ADDENDUM NO. 01

CITY OF PORT ARANSAS CITY HALL / CIVIC CENTER EXPANSION AND RENOVATION

TRA PROJECT NO. 2023-29

Issue Date: March 11, 2025

DOOR FRAME TYPE

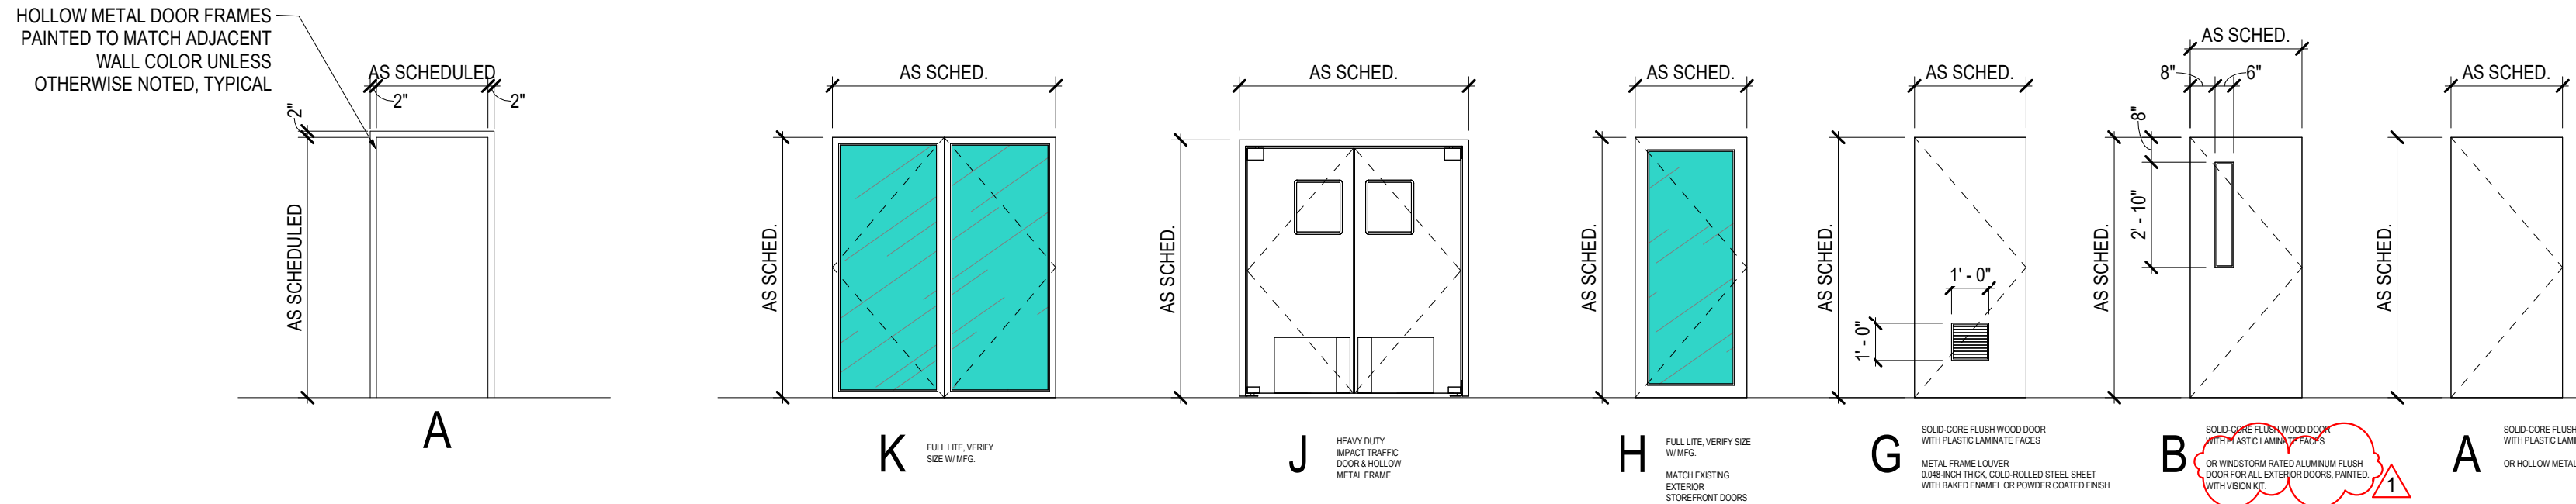
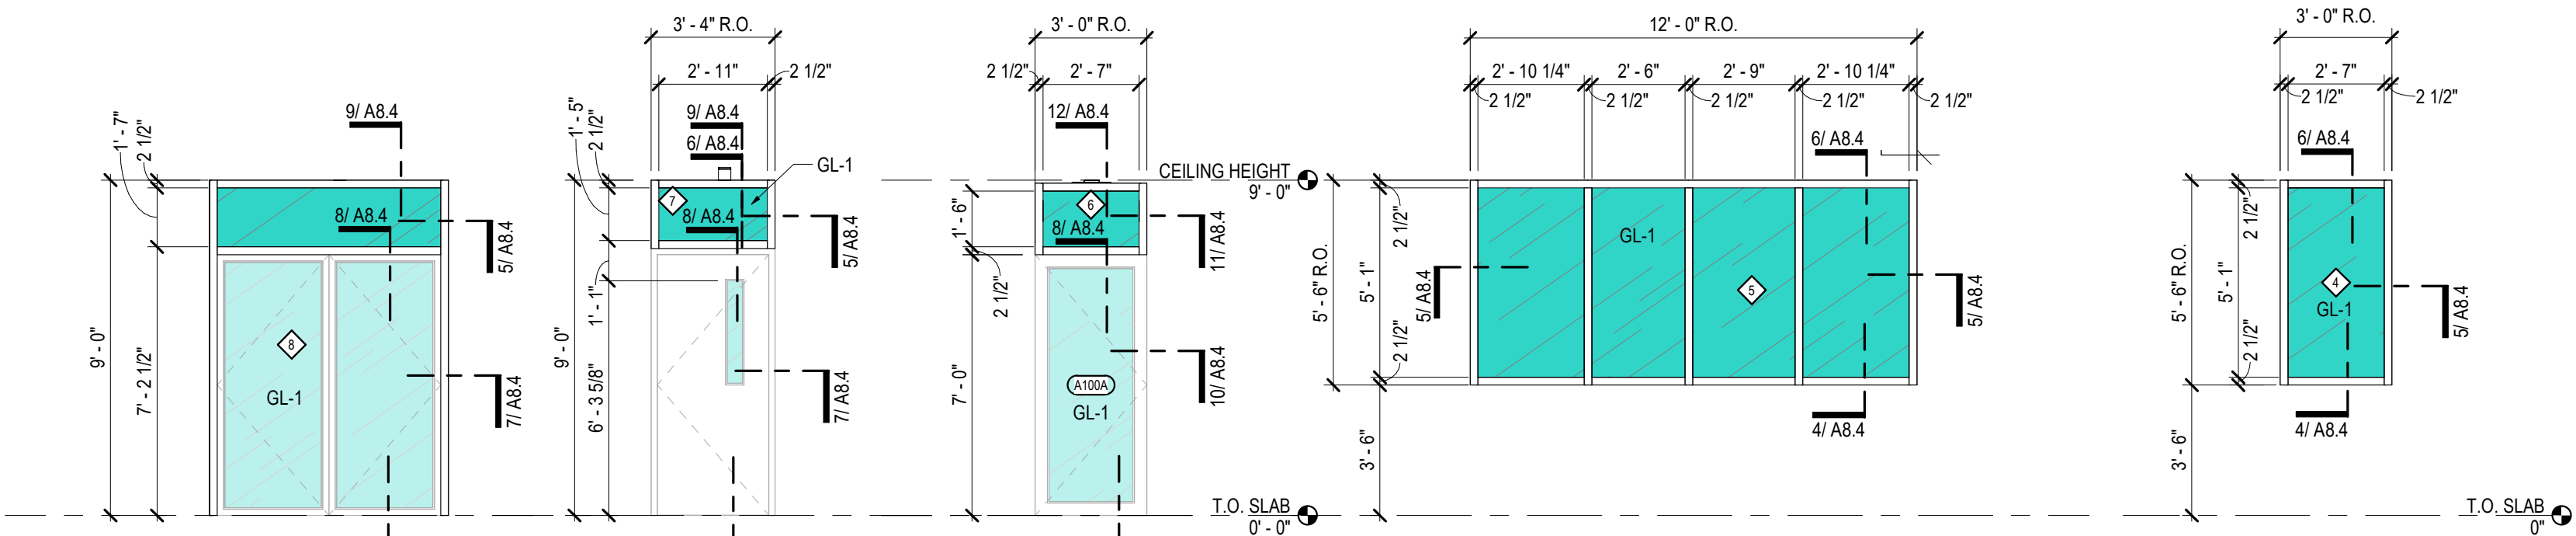
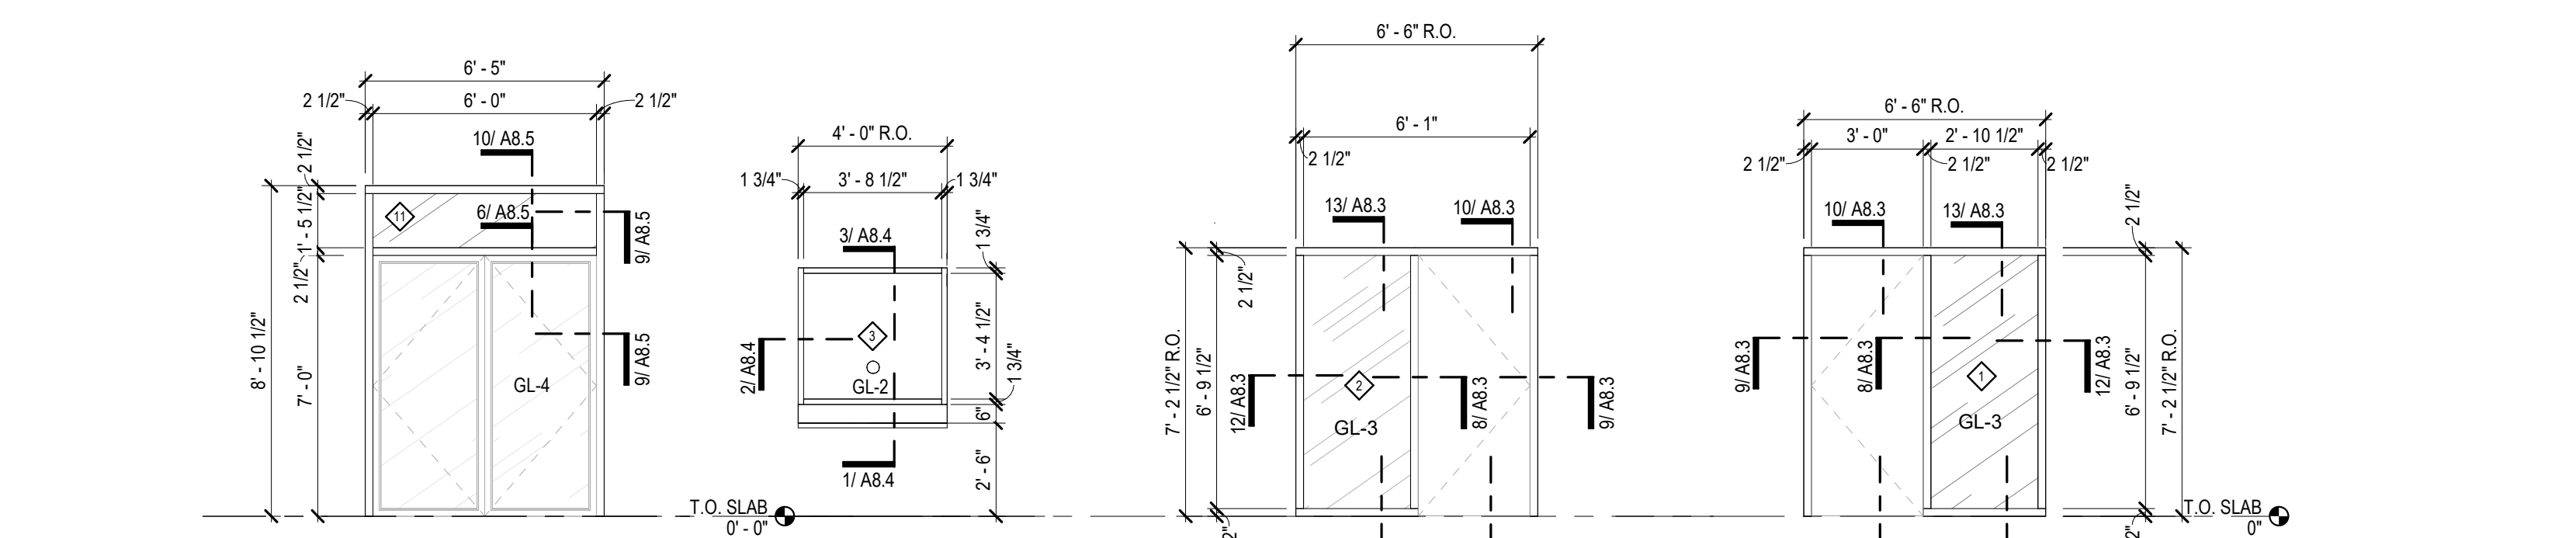
Q3: Glazing Legend – Sheet A8.1/GL-4: Glazing type GL-4 is listed as 45-minute fire rating glazing. Schedule shows this glazing being used at 90-minute rated locations. Please confirm that GL-4 should be listed as 90-minute fire rated glazing.

RESPONSE: Glazing Type GL-4 should be listed as 90-minute fire-rated glazing.
